IN THE DRAWINGS:

REMARKS

U.S. Serial No. Unknown
Filed: Herewith
Applicant: Weatherford/Lam
Inventors: William F. Howard, et al.
Express Mail No.: EV351031040US
Sheet 1 of 2

Fig. 1

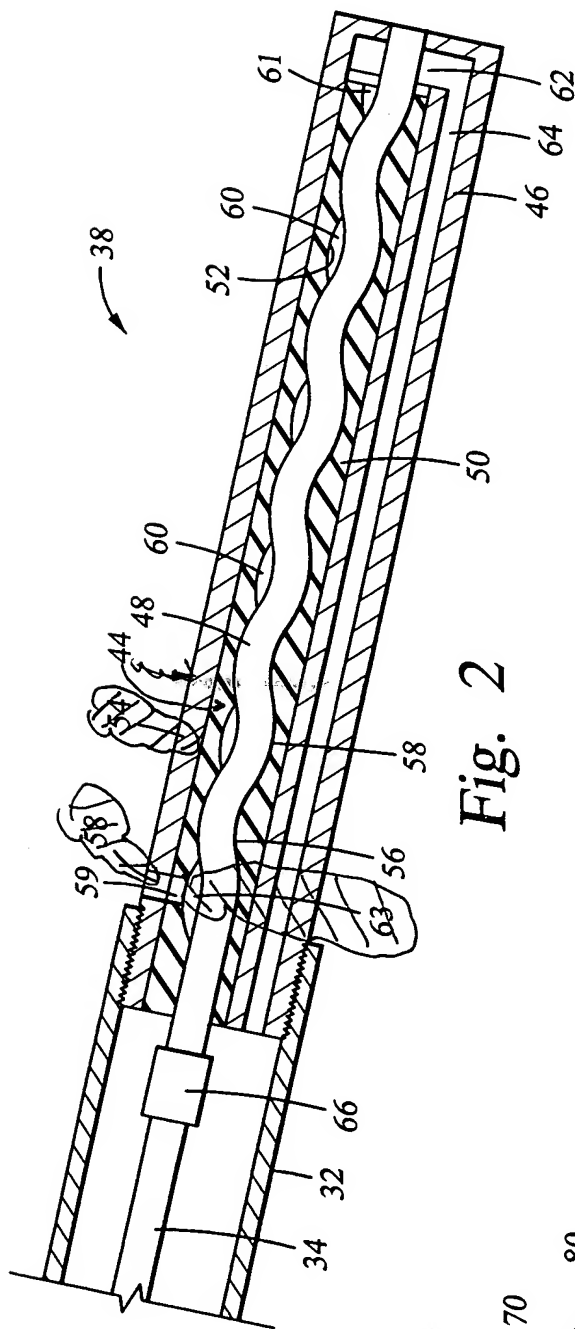
In amended Figure 1, the previously omitted element numeral 27 has been added. Further, a controller 33 shown schematically and a wire 31 have been added in accordance with the specification. No new matter has been added.

Fig. 2

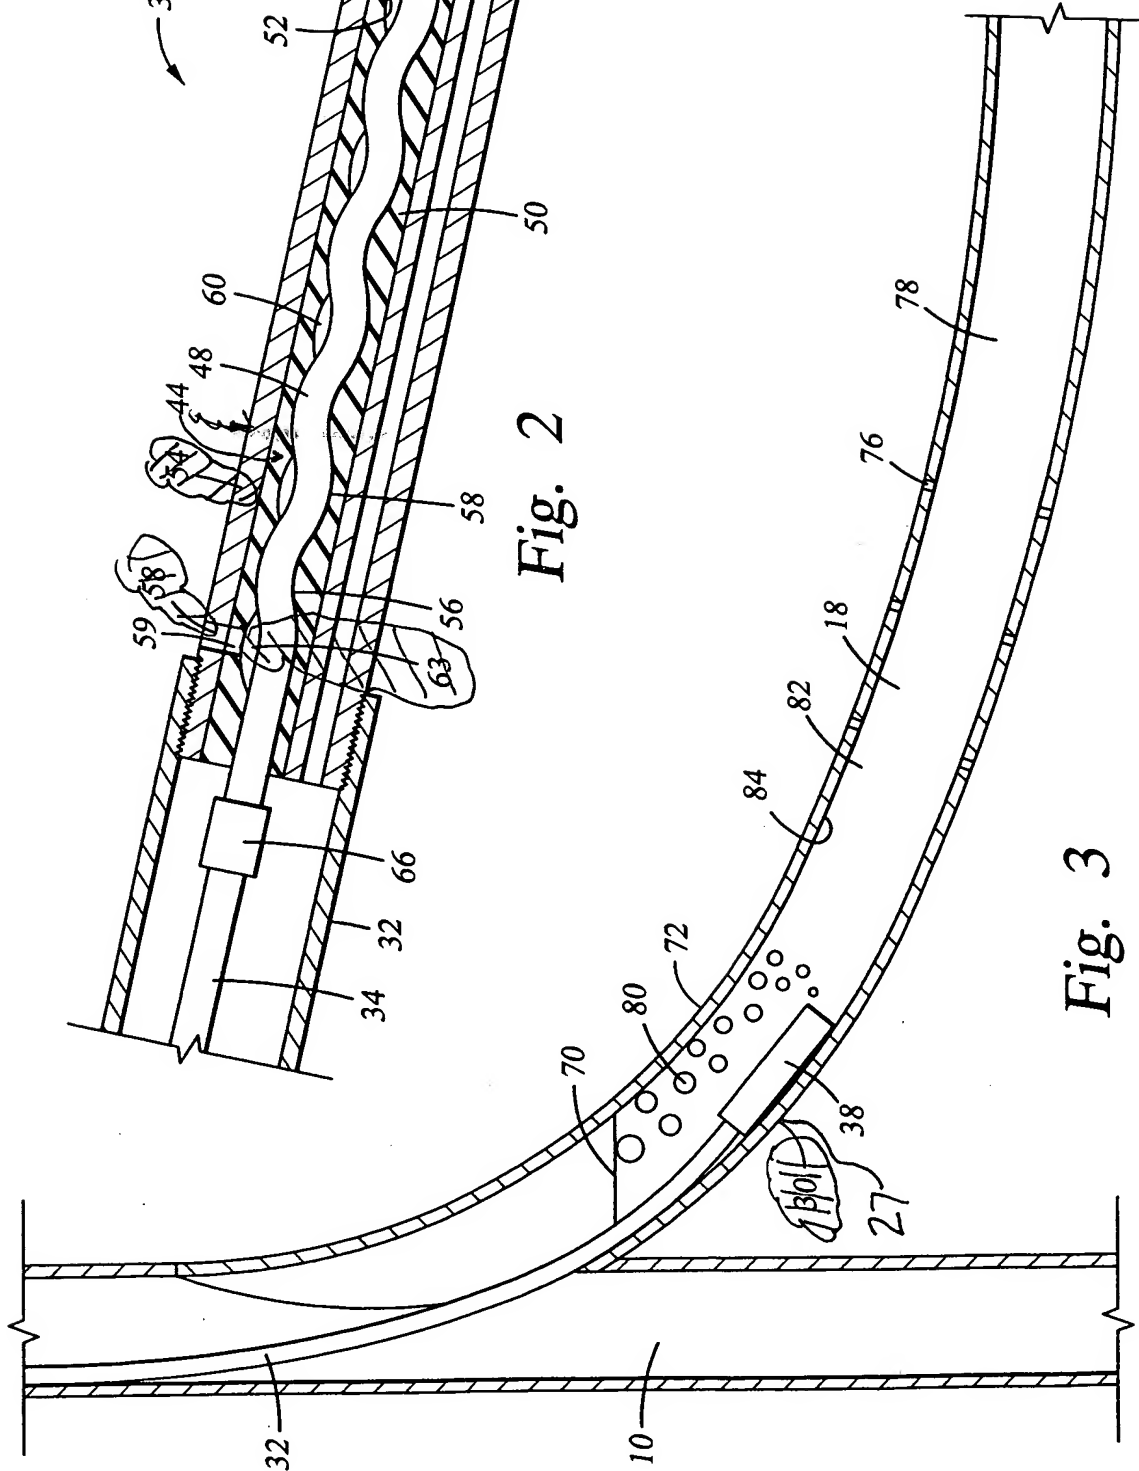
In amended Figure 2, element numerals 54, 58 and 63 have been deleted.

In amended Figure 3, element numeral 30 has been changed to element numeral 27 in accordance with the specification. No new matter has been added.
